**BEFORE AN INDEPENDENT HEARINGS COMMISSIONER  
AT NELSON**

**COUNCIL REF: RM200488,  
RM200489 AND RM220578**

**STATEMENT OF EVIDENCE OF DR MICHAEL HARVEY ON BEHALF OF VALLEY RESIDENTS  
AGAINST GRAVEL EXTRACTION (FLOOD PLAIN, STOPBANK AND EROSION IMPACTS)**

Dated 11 November 2022

Figure 4. Time series of velocity for model cell immediately adjacent to modelled borrow pit for the 1% AEP flood event (Aiken, 2022, Figure 6)

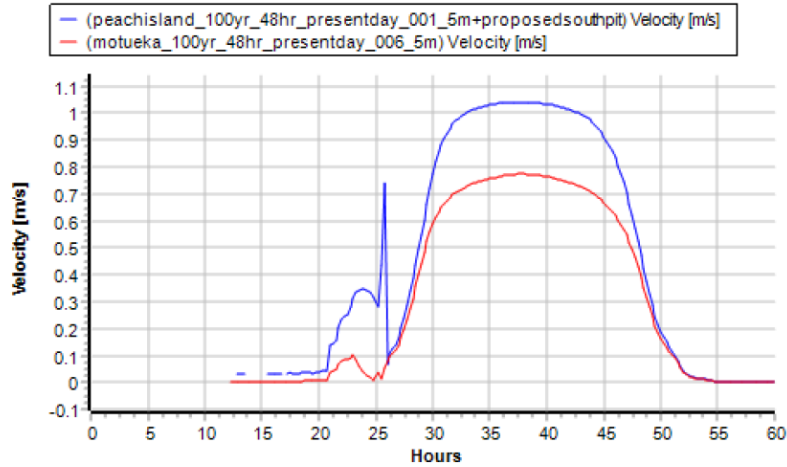
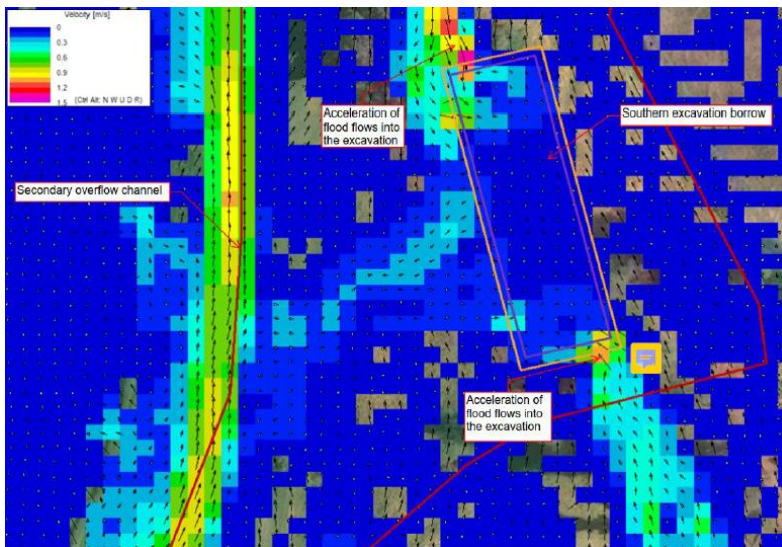
25. Acceleration of flood flows into both the upstream and downstream margins of a modelled pit (Figures 4 and 5; Aiken 2022) prior to the pit filling clearly indicate that erosion of the pit headwalls (headcutting) will occur during a flood event (Kondolf, 1997). This will release fine sediments (sands, silts and clays) from floodplain storage (topsoil and subsoil thickness varies from 0.5m to 1.0; Corrie-Johnson, 2022 3.7) into the flows thereby increasing the suspended sediment load that ultimately will be transported downstream to the Motueka River and then into Tasman Bay. The potential for this mode of erosion was not evaluated by Tonkin & Taylor even though its omission had been identified in my previous submission (27 January 2022). Visual evidence of the headcutting process on the Motueka River floodplain can be seen in Figures 6 and 7 which were taken at the head of the Douglas Road pit following the 17-18 July 2021 flood.

26. Contrary to the statement by Mr Aiken (3.14) that he considered the scenarios assessed in the Tonkin & Taylor report as being conservative representations of the proposed activity because a significantly larger excavation footprints was modelled

(30m X 100m) than is currently being proposed (20m x 80m), engineering literature (Barman et al., 2019) indicates that the headcut erosion potential at the upstream pit margin increases as the Length/Width ratio of the pit increases. Reduction of the pit dimensions from 30m x 100m to 20m x 80m increases the Length/Width ratio from 3.3 to 4 and therefore is likely to increase the headcut erosion potential for any given borrow pit.

Figure 8. Modelled flow distribution of the 1% AEP event showing the hydraulic connection of the backchannel and the Motueka River in the vicinity of Peach Island. (Image provided by R. O'Grady, TDC, from Peach Island Flood Response and Mitigation Public Meeting 2 November 2021)

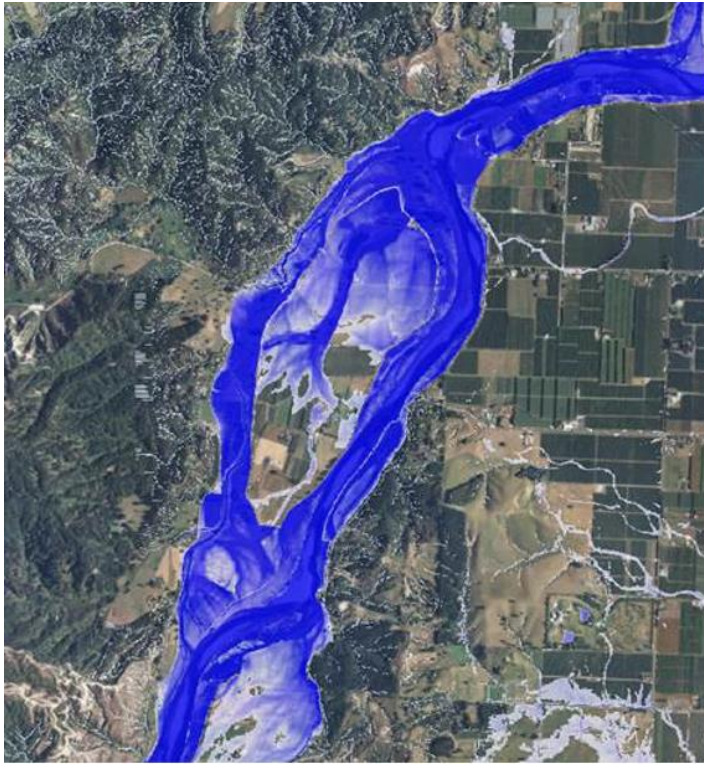
29. Soil textures in the Stage 1 mining area are predominantly silt loams (LandVision, Ltd. 2021) composed of sands (~20%), silts and clays (~ 70%). Permissible velocities (i.e. non-eroding velocities) for these soil textures range from 0.46 m/s to 0.69 m/s (Table 2; Fischenich, 2001), and therefore velocities in excess of these values are likely to cause erosion. Time series velocity plots on the floodplain in the Stage 1 mining area for the existing conditions 100-yr ARI event (Figures 9 and 10; Aiken, 2022), show that the velocities on the floodplain exceed the range of permissible velocities for most selected locations (Figure 3; Aiken, 2022) for durations of between 20 and 30 hours. Under these conditions, bare, uncompacted soils of these textures are expected to erode thereby increasing the fine sediment delivery to the Motueka River and Tasman Bay. While time series plots of velocities for the 10% AEP event were not produced, it is likely that the absolute velocities over the floodplain will be of the same magnitude, or possibly higher, than those for the 1% AEP event because

of downstream backwater caused by flow constriction below Peach Island (refer to Figure 8).

Figure 11. Schematic of Motueka River stopbank construction methods during construction in the 1950's showing lack of compaction in the stopbank core (TDC, 2010; Motueka Flood Control Project, Newsletter Issue 01, July 2010)

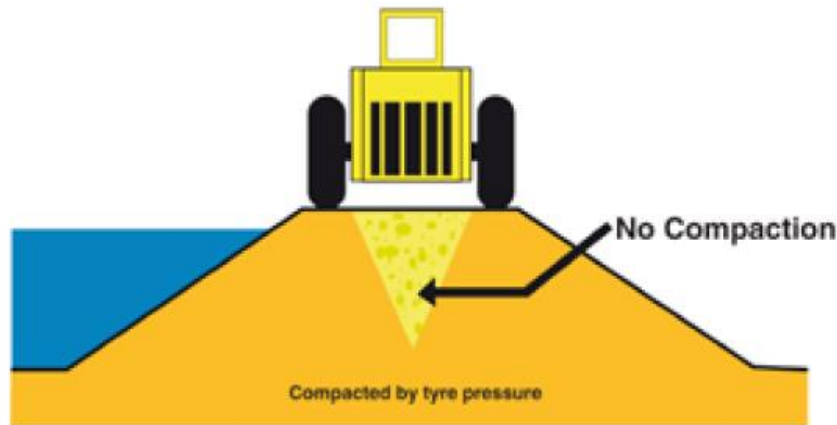
30. I agree with Mr Averill that the proposed mining, provided that the 20m setback from the levee toe is maintained, is unlikely to adversely affect the stability of the existing Peach Island stopbanks (Averill, 2022; 2.3). However, because the stopbanks were constructed in the 1950's from local floodplain materials with methods that are unacceptable today (Figure 11) there is a risk that there will be failure (Figure 12), primarily as a result of seepage or sloughing of a saturated embankment during a flood event with an undetermined ARI (Tonkin and Taylor, 2020, p.4). Maintenance activity on the Peach Island stopbanks is intermittent and there is evidence of stock tracking and rabbit burrowing, both of which compromise the integrity of the stopbanks (TDC, Rob O'Grady meeting notes, 2 November 2021.) If the stopbanks were to fail, stockpiles of overburden material, topsoil and backfill material stored between the stopbanks at all 3 stages of the mine life would be at risk of erosion and

would significantly increase fine sediment loading to both the Motueka River and Tasman Bay.
